**TOWN OF COVENTRY, RI  
DEPARTMENT OF PLANNING & DEVELOPMENT**

## STAFF REPORT

<b>Project Name:</b>	<b>Bucks Horn Meadow</b>
<b>Plan Type:</b>	Major Subdivision / Residential Cluster Development
<b>Plan Review Phase:</b>	Final Plan
<b>Owner/Applicant:</b>	Padula Builders, Inc.
<b>Address:</b>	Flat River Road
<b>Plat / Lot / Zone:</b>	<b>AP 315 Lots 80 &amp; 95</b> <b>Zone RR-5 Lot Size 53.2 acres</b>
<b>Existing Use:</b>	Vacant Land
<b>Proposed Use:</b>	7-Lot Residential Subdivision
<b>Description:</b>	The applicant proposes to construct a 7-lot cluster subdivision on a 53.2-acre site and dedicate 37.8 acres as open space.

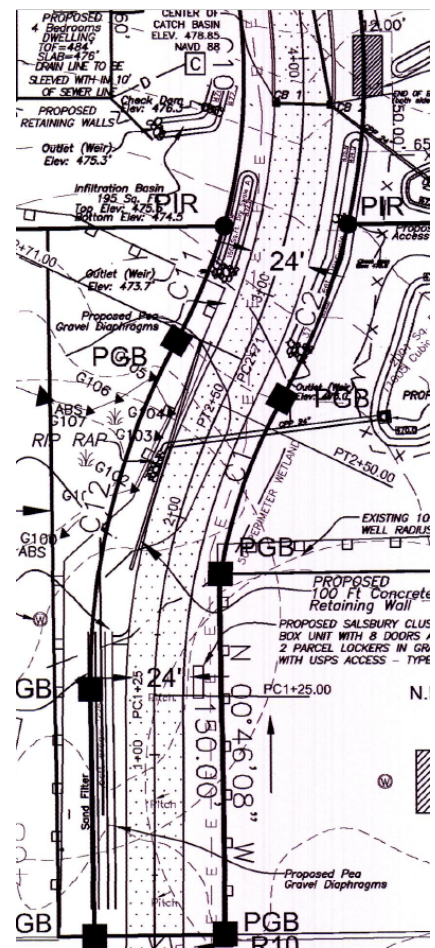
While most of the public and private improvements, including the new roadway, retaining walls, and drainage improvements, have already been constructed, there are roadside drainage features that have not yet been completed (see cropped site plan). The applicant now intends to complete the construction of the remaining roadside drainage features after Final Plan recording and endorsement, inconsistent with condition #8 above. As a result, the Final Plan decision will require an amended condition of approval for the adjusted bond, subject to Planning Commission review and approval (rather than proceed administratively). The draft conditions are provided following the findings of fact and staff recommendation

3. The applicant shall complete the construction of all required drainage improvements, including the incomplete roadside drainage features, and submit an associated Certificate of Conformance for those improvements prior to receiving the first building permit Certificate of Occupancy for this project.
